A G E N D A

Architectural Review Board

March 28, 2023 – 5:30 p.m.

Front yard (to scale)

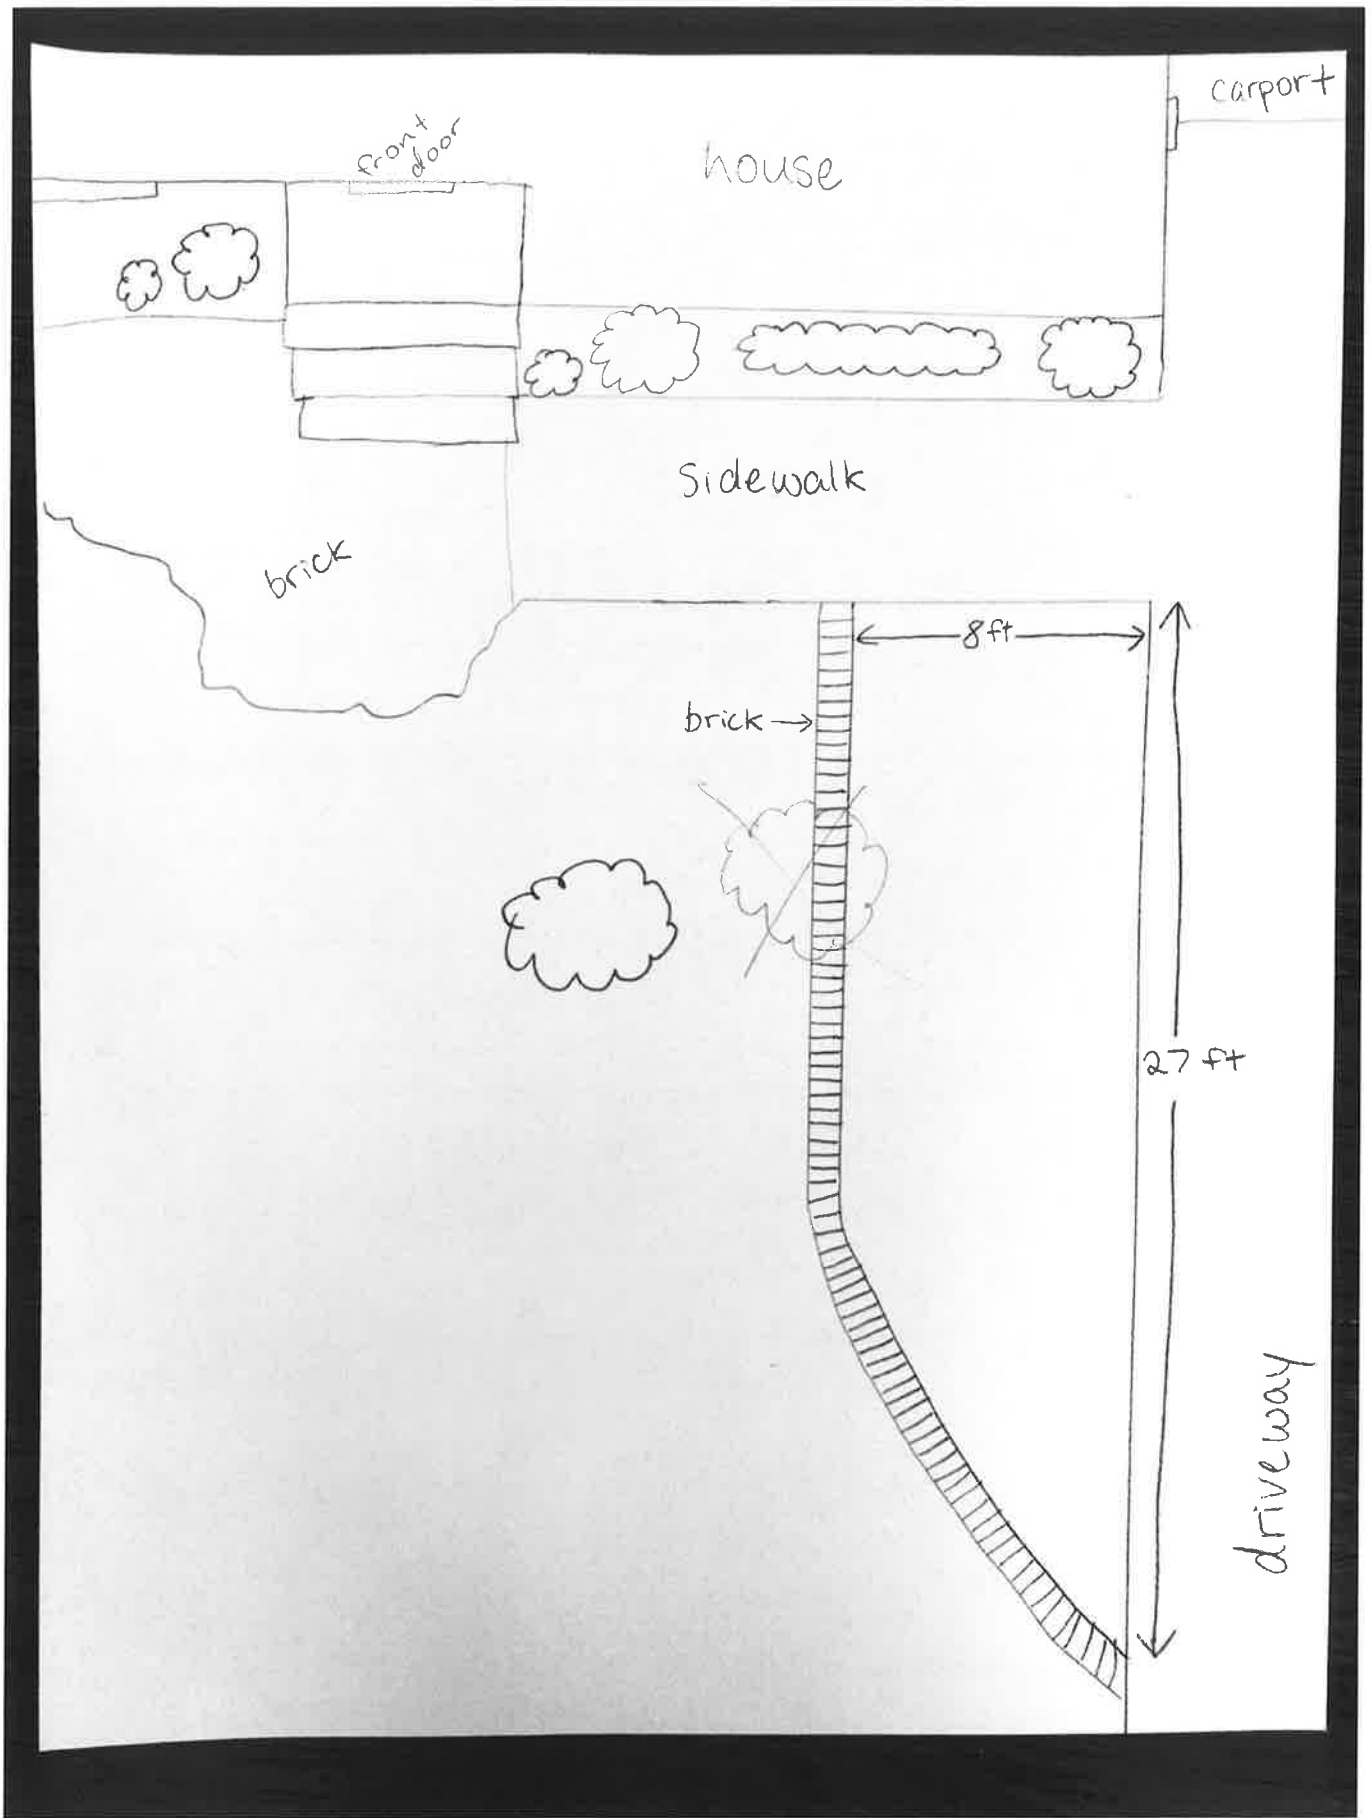
- This request was carried over from the February meeting.
- A street-facing garage door is a mid-century modern addition to residential language in the US. The current carport is proportionate and well designed to the historic house. Enclosing it to make a garage would not be appropriate.
- A suggestion may be to widen the driveway to the right side. This keeps from blocking any portion of the front of the house.
- Widening the driveway would have an adverse effect to the appearance of the house. Although it is an annoyance to stack and back cars into the street, your street is wide enough and substantially residential in nature that would accommodate that.

3A

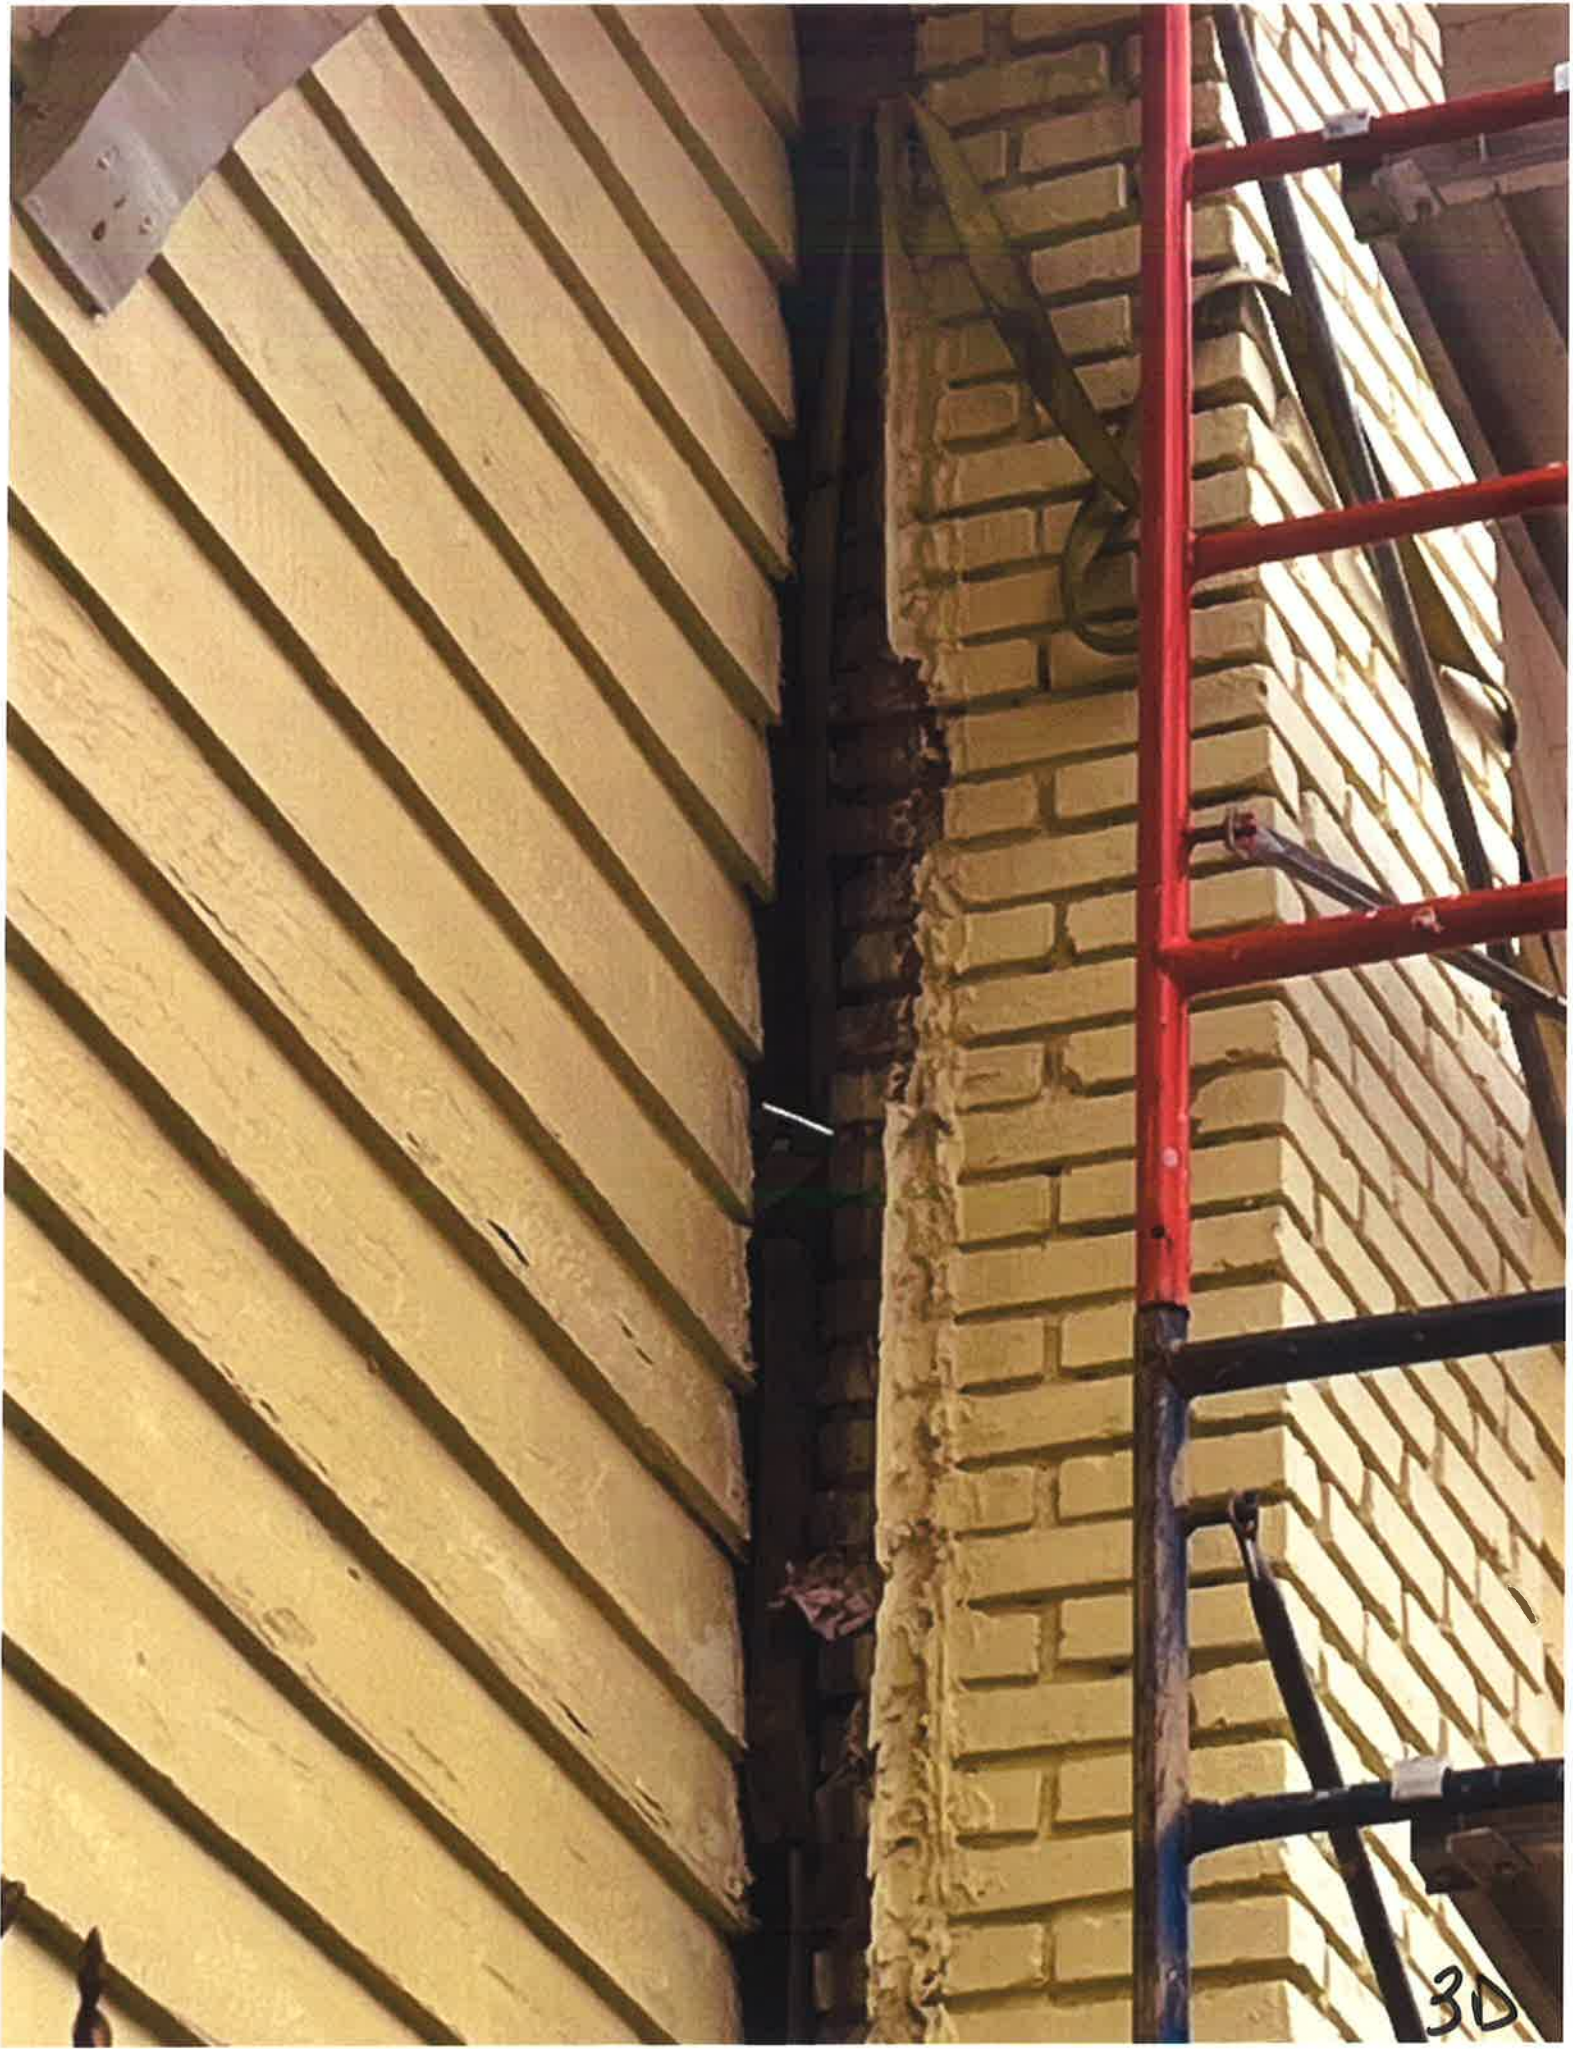
- An advisory was given by the Board at the February meeting and agreed to allow Ms. Gordon to proceed with removal of the chimney at that time. This request is to ask permission to not rebuild the chimney.

4A

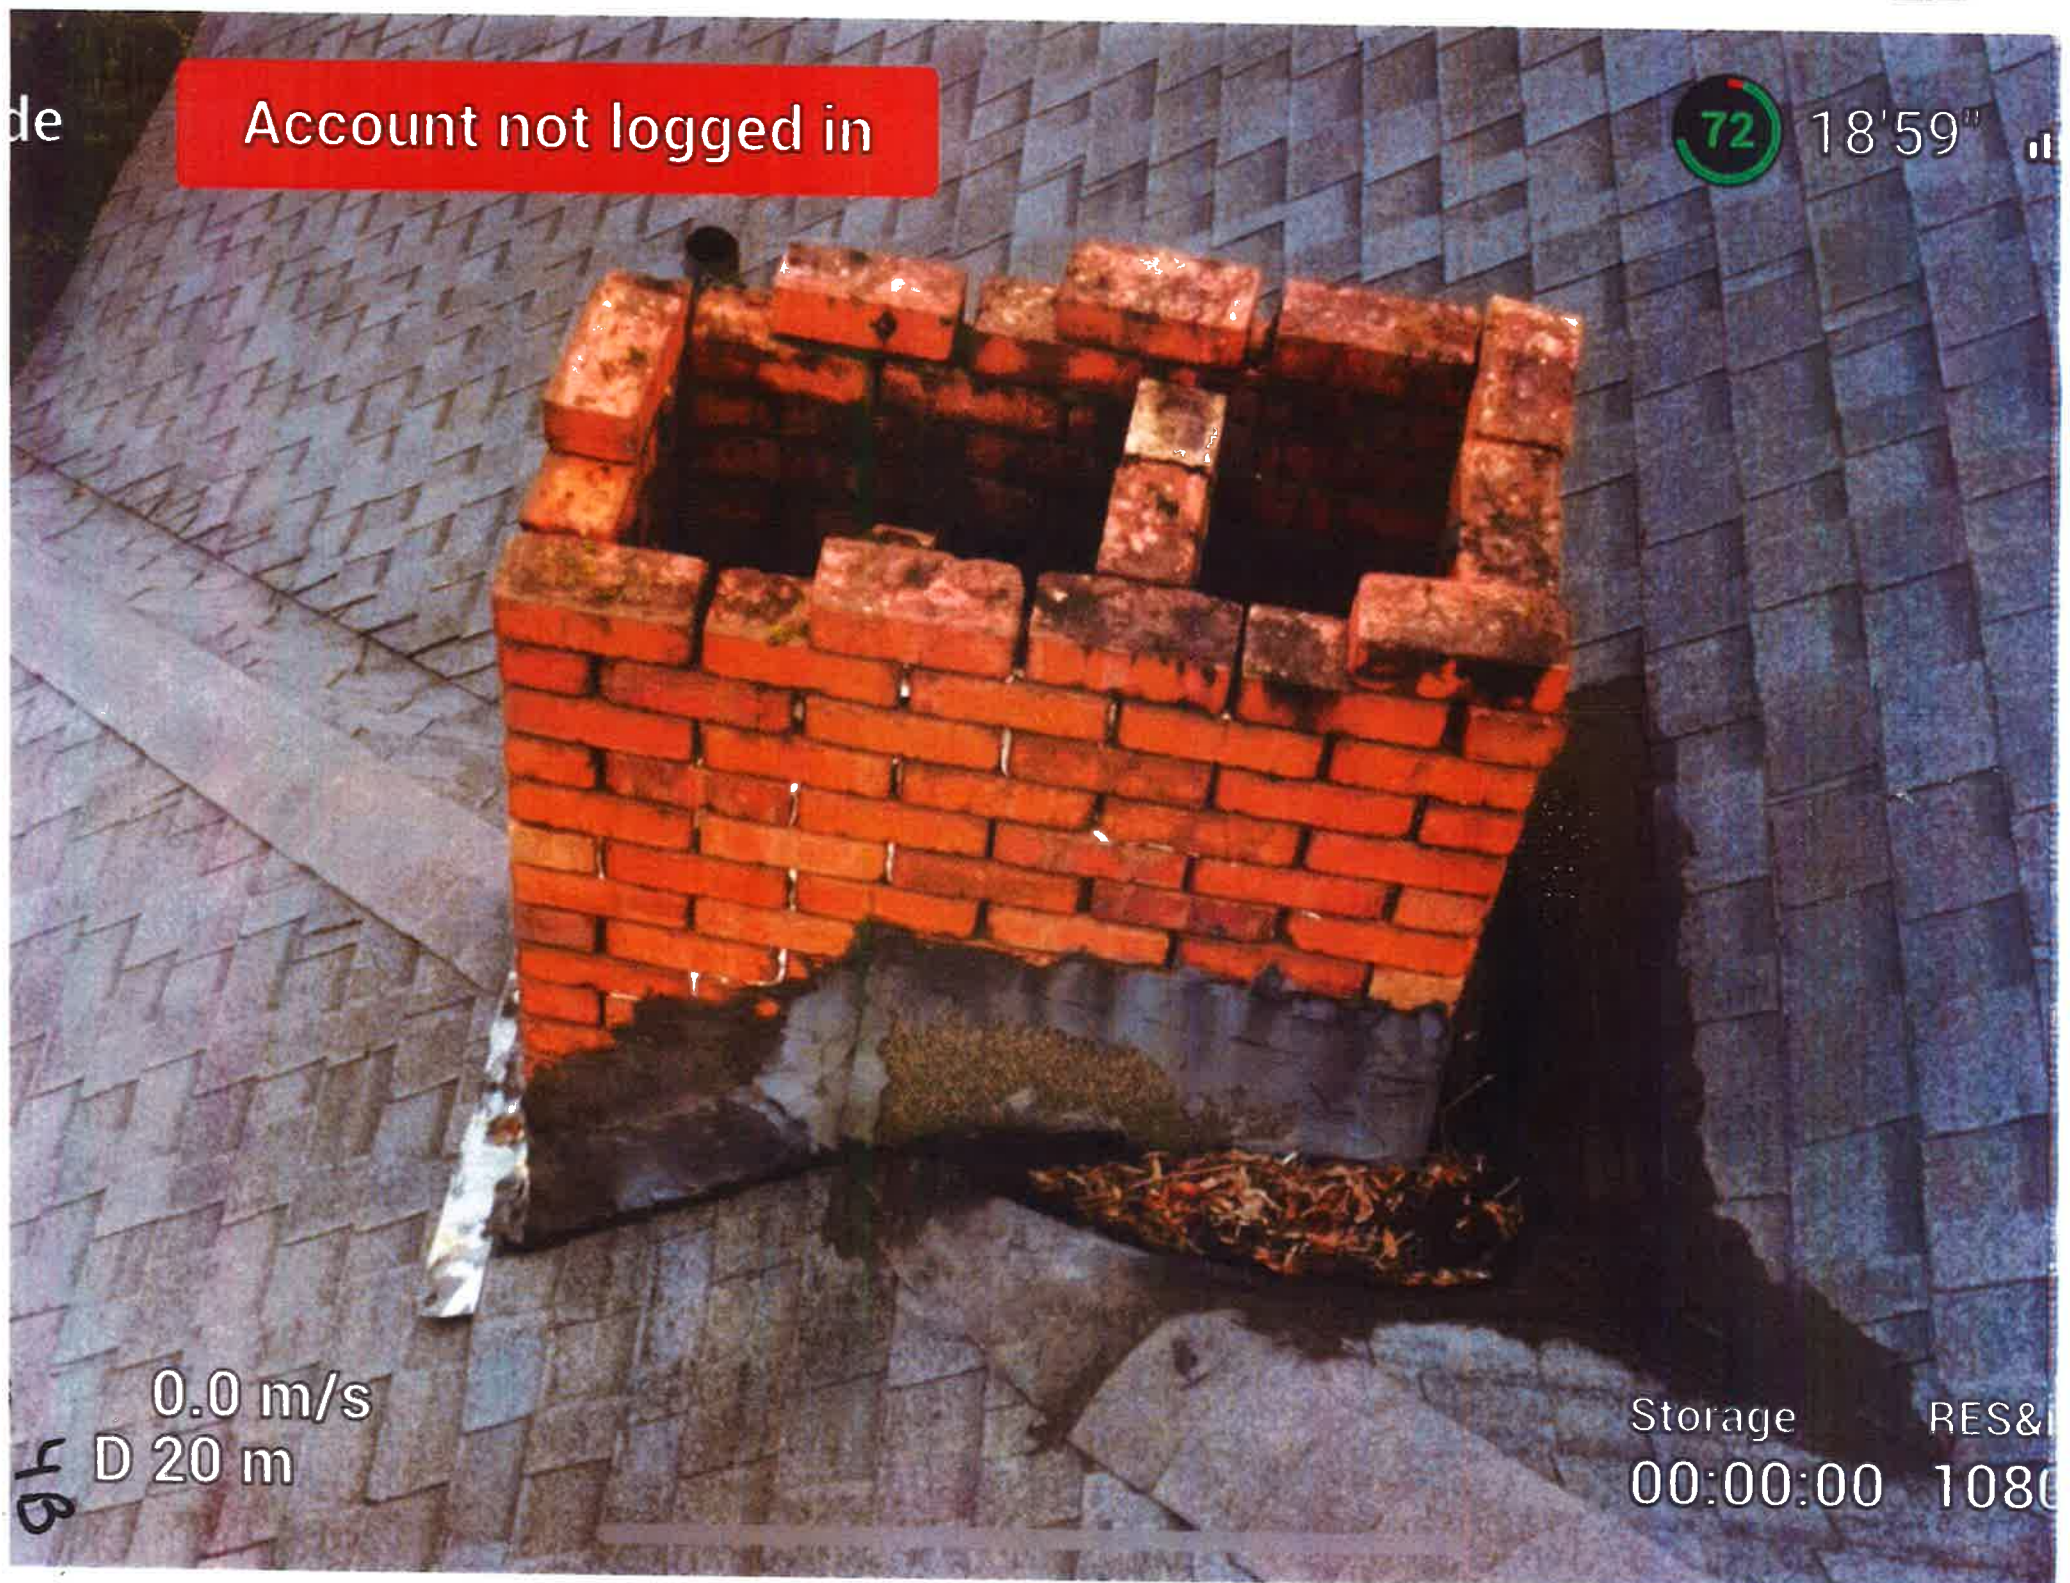
- An advisory was given by the Board at the February meeting and agreed to allow Mr. Campbell to proceed with removal of four (4) chimneys at that time. This request is to ask permission to not rebuild the chimneys. Two were visible from the street.
